Q9.99_V1.1 known issues

for STM ATB V1.1

STMA-81405 - This document lists the "known issues" for STM ATB version 1.1

Definition, STMA-82859 - Power supply options

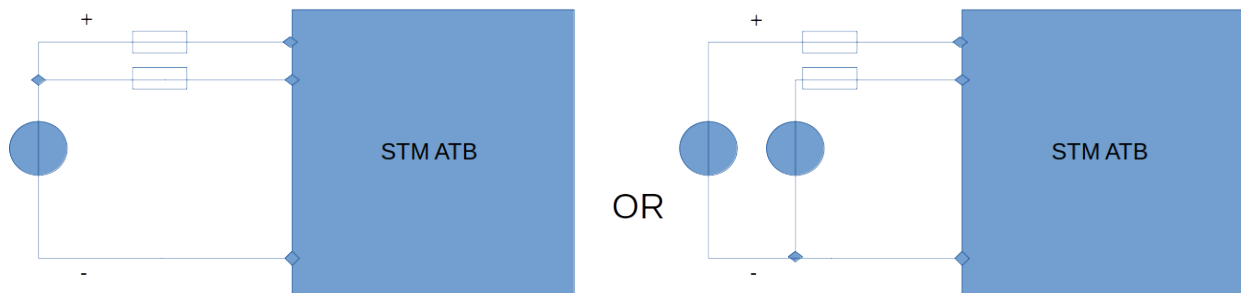
STMA-82858 - In  [STMA-68344](#) - The STM ATB shall be electrically connected to: * ETCS onboard sytem (Profibus i... i t is stated "...commonly supplied via one multi signal circuit breaker". During installation projects it appeared this formulation is unclear. The intention is that both power connections shall be supplied from a voltage source with a common minus, and separately protected plus lines. See figure below, where the indicated fuses may any kind of protection, fit for the STM ATB supply voltage and current.
